ADDENDUM ONE

Project: **Sullivan County East Middle School Porch Enclosure**

November 7, 2023

G-12

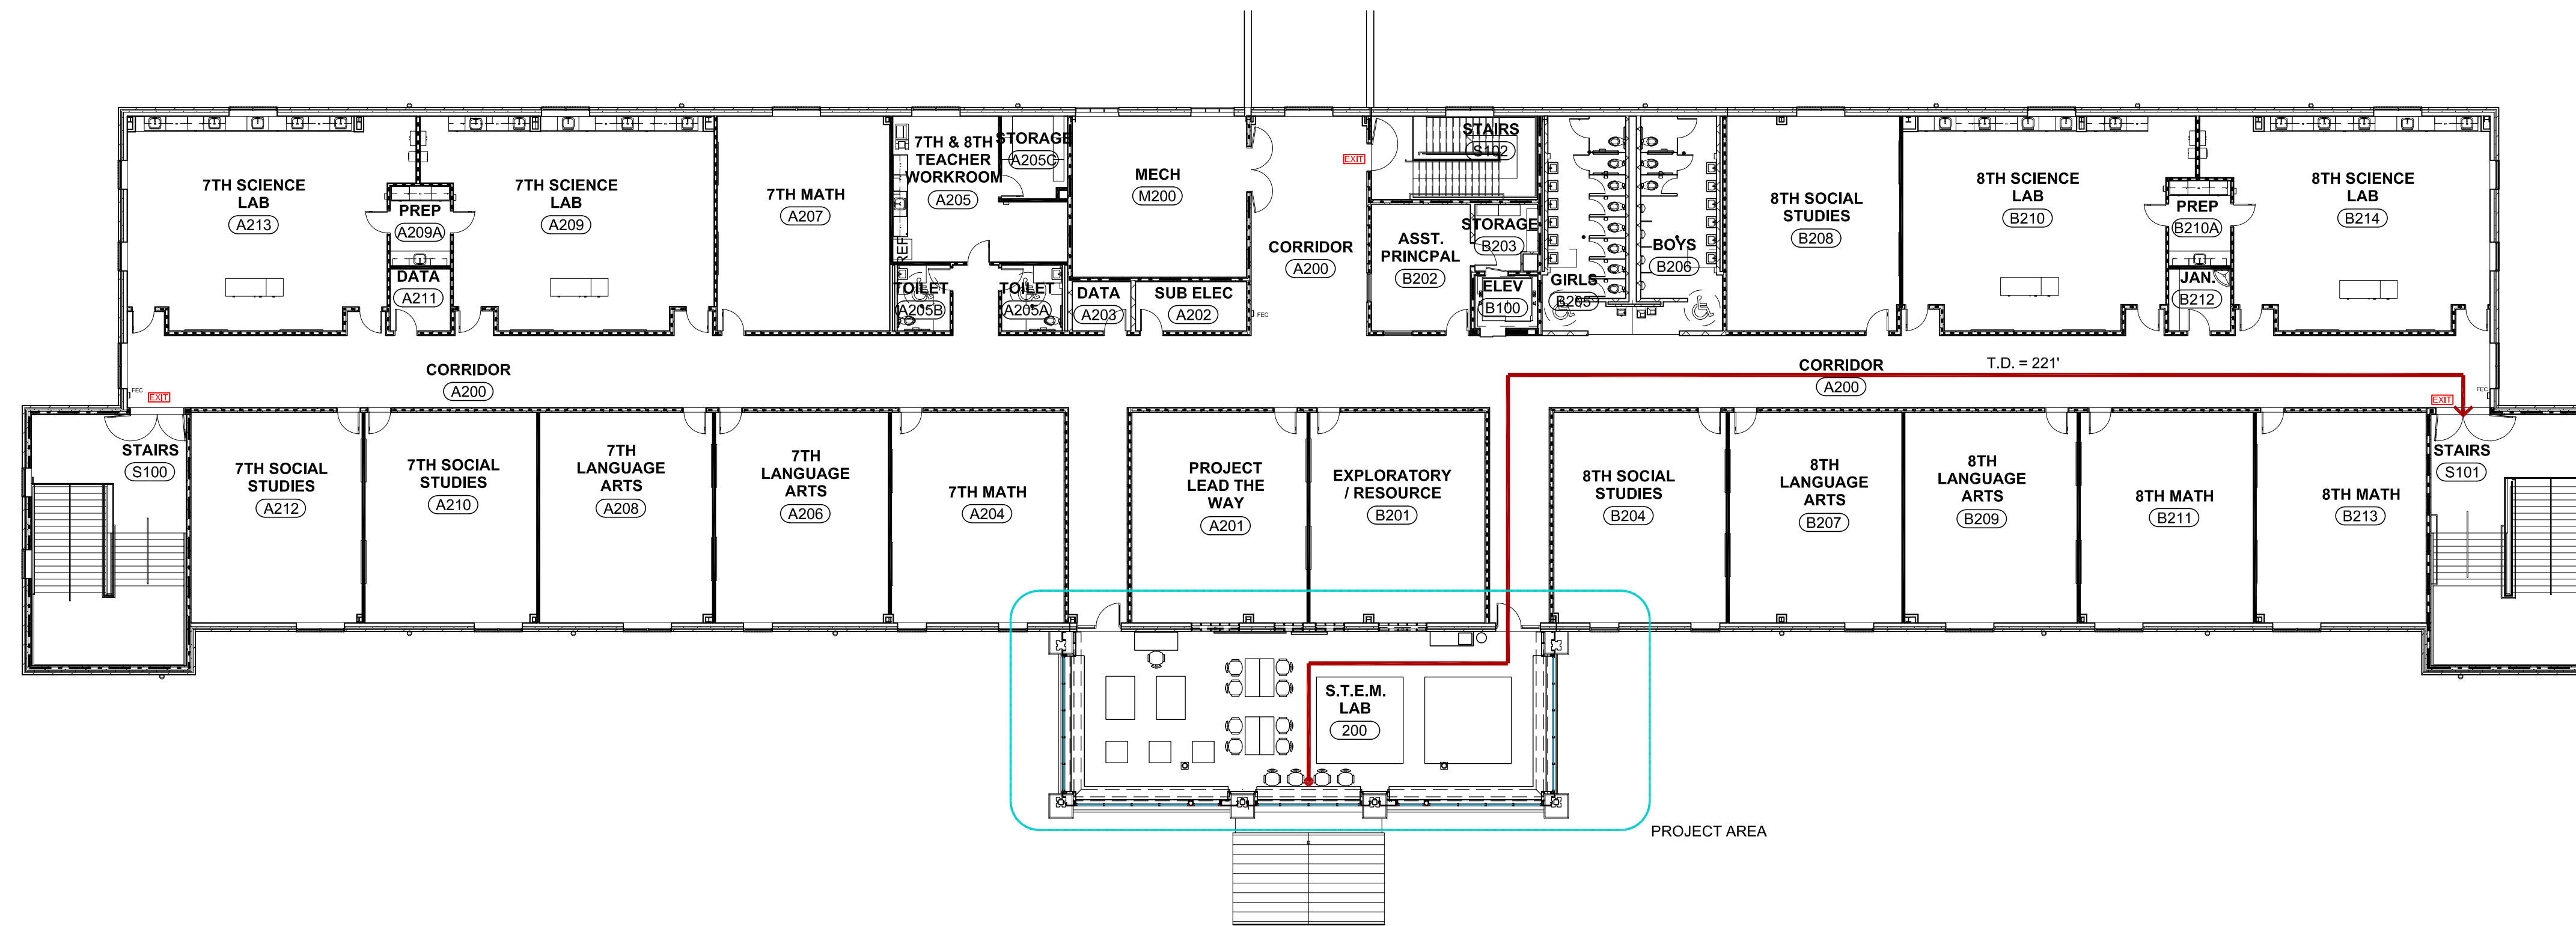
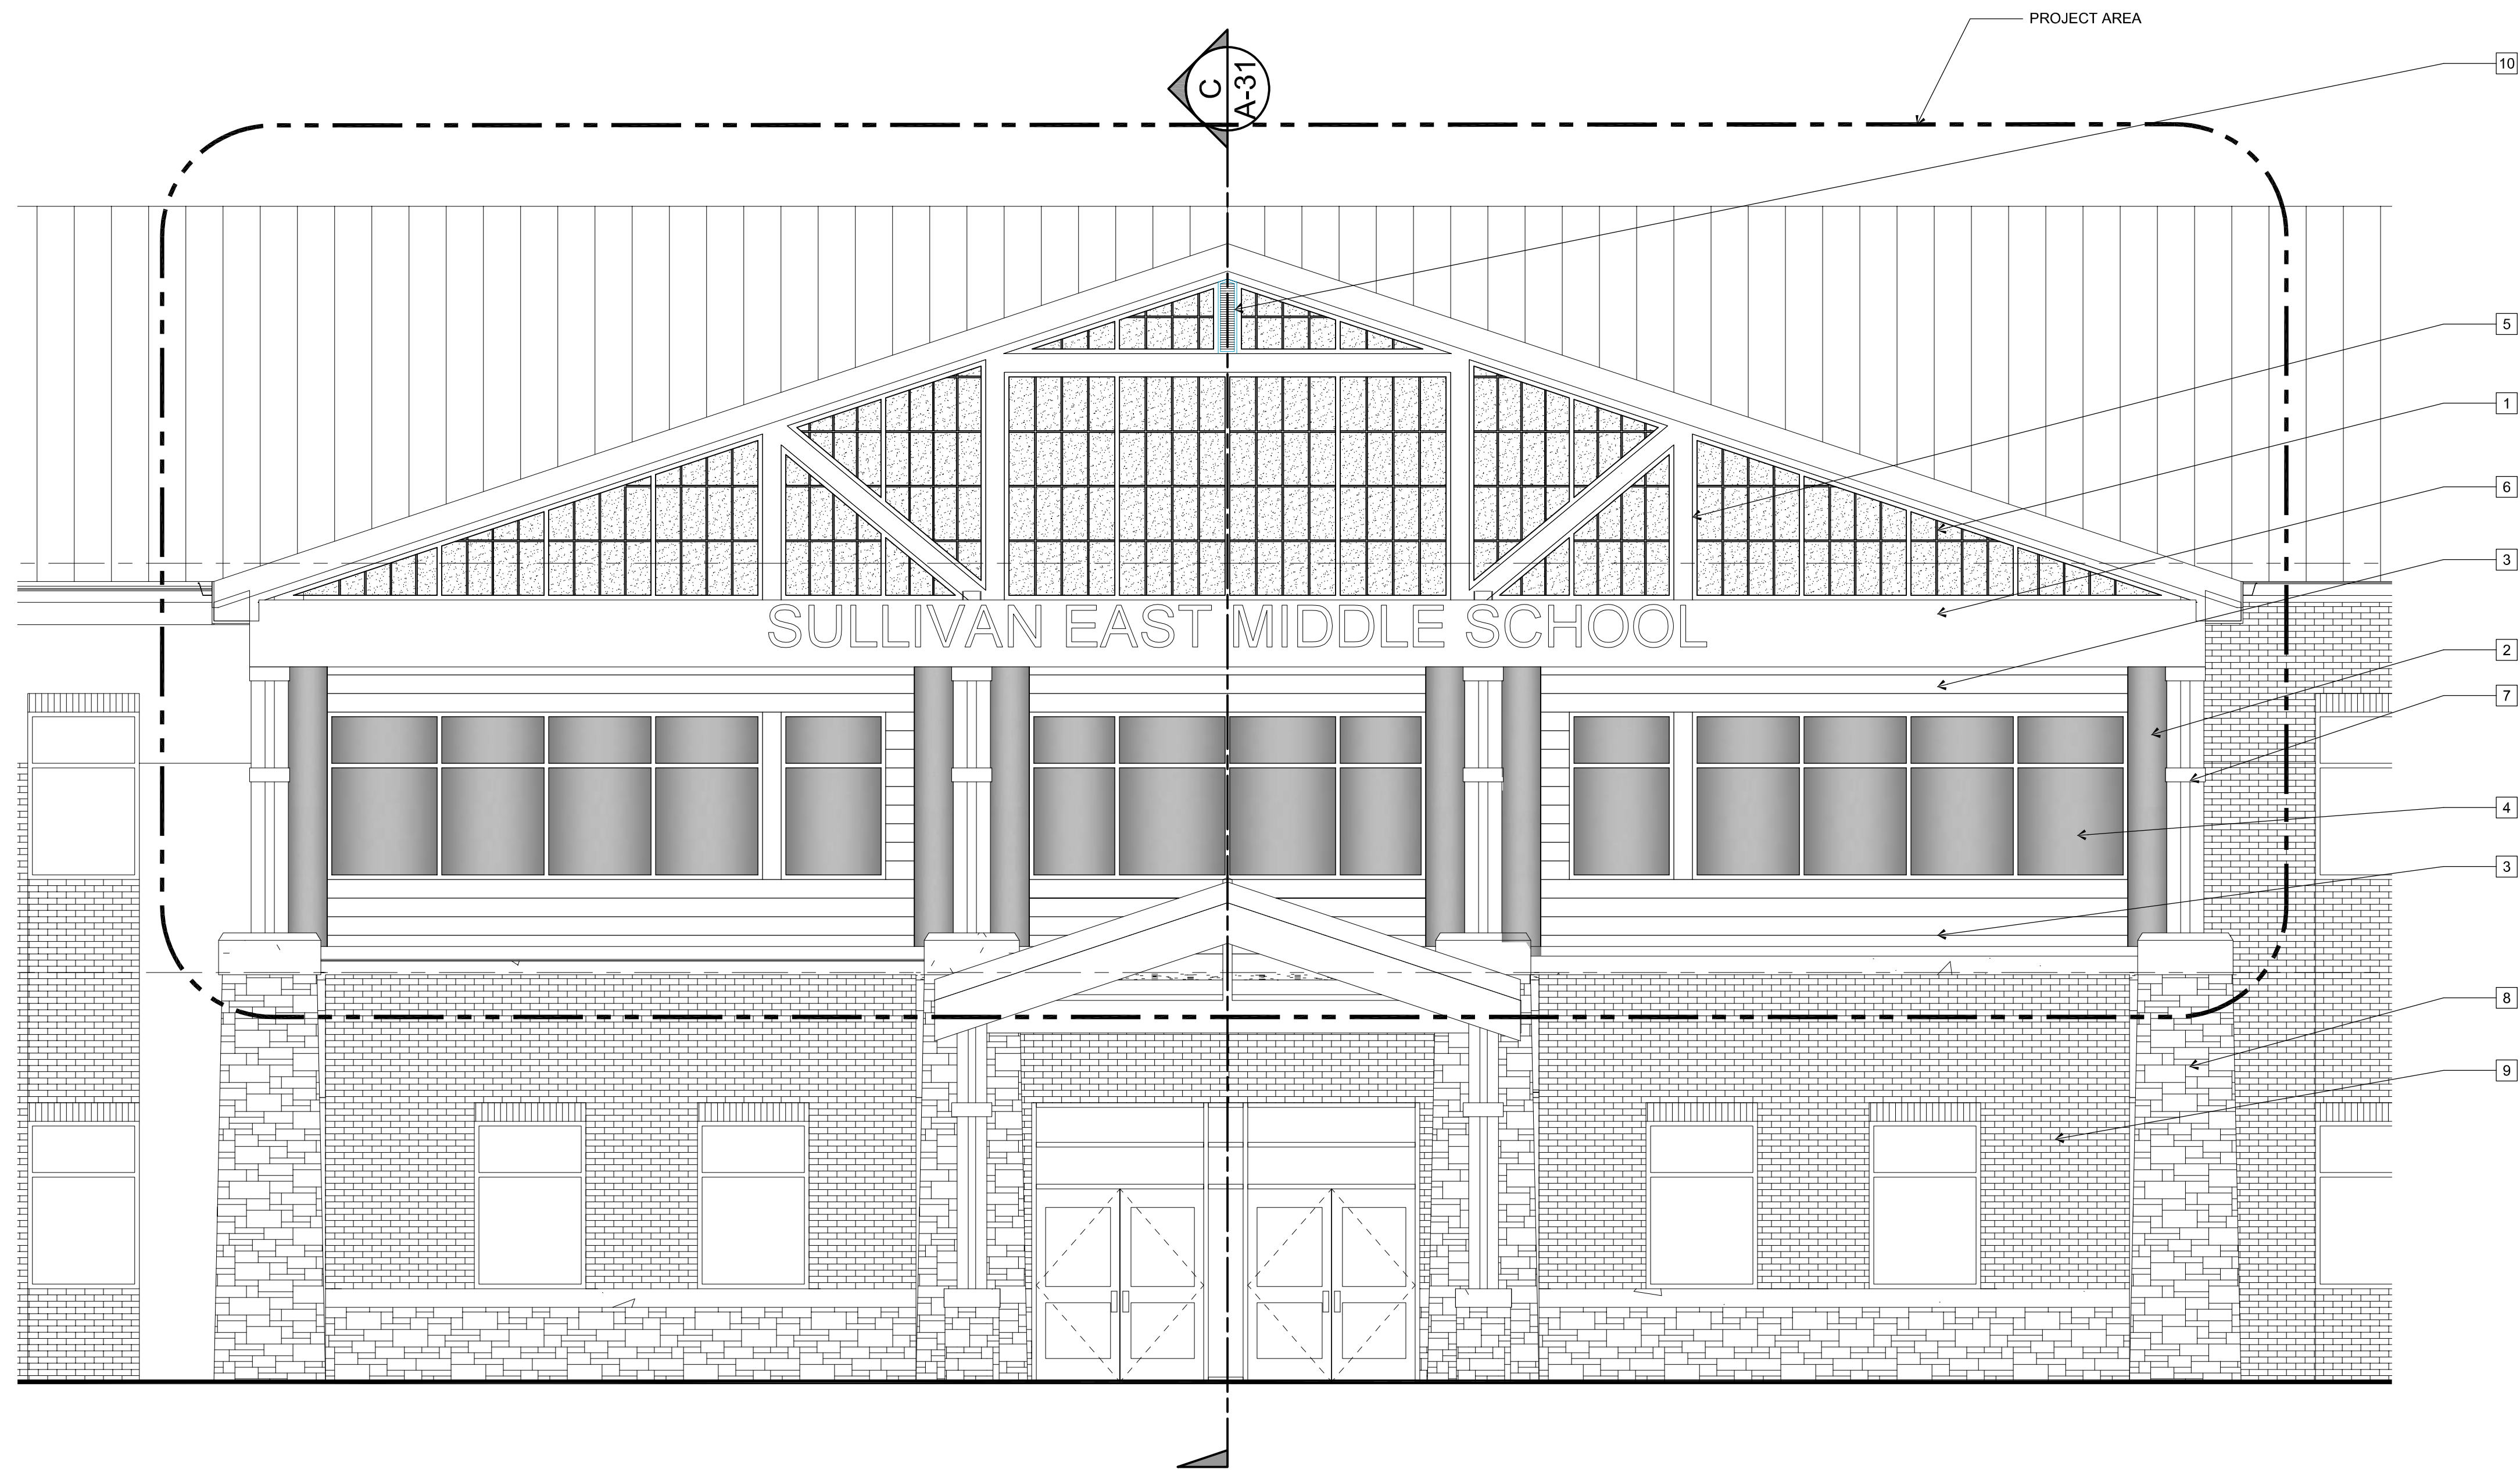
1. **Drawing G-12** has been revised to include the International Existing Building Code, 2012 Edition, excluding Chapter 11 and Section 3411, and the inclusion of the International Existing Building Code, 2012 edition (scope of work related to existing buildings).

E-01

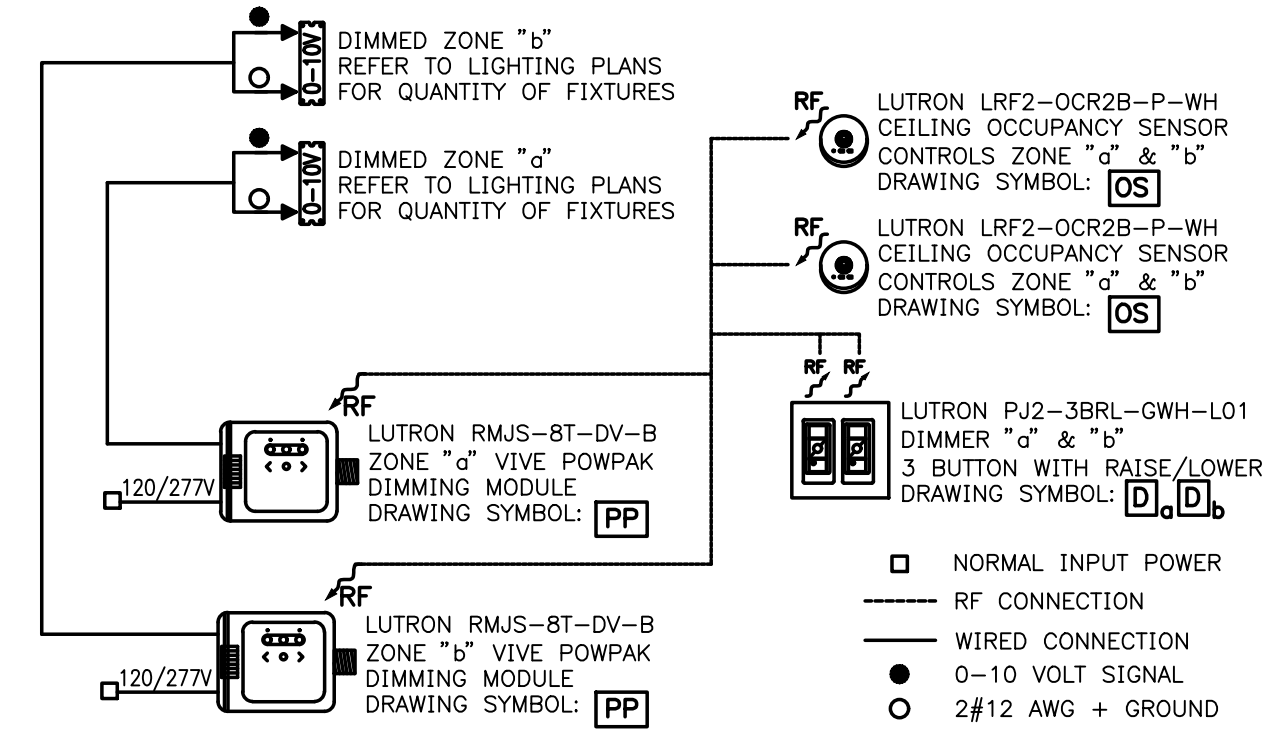
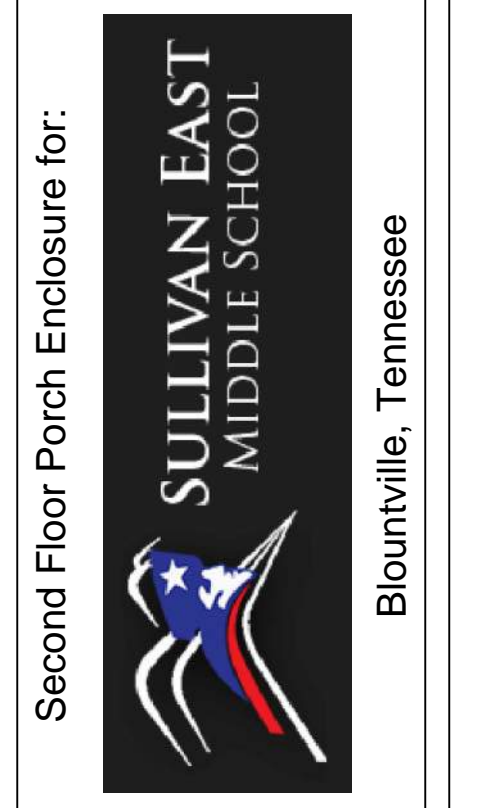
2. **Drawing G-00** has been revised to show the TFM#, the County of the project and corrections to the Drawing Index.
3. **Drawing E-01** has been revised to include a symbol for the Emergency Lighting.

7. **Drawing E-01** has been revised to add the combination exit sign/emergency egress lighting unit to the Electrical Specifications. The specified product (Lithonia Quantum LHQM series) has a built-in UL listed battery which provides the required minimum 90 minutes of emergency egress illumination in the event of a normal power loss.

8. **Drawing E-01** has been revised to add the requested notes.
9. **Drawing E-01** has been revised to add the requested notes.
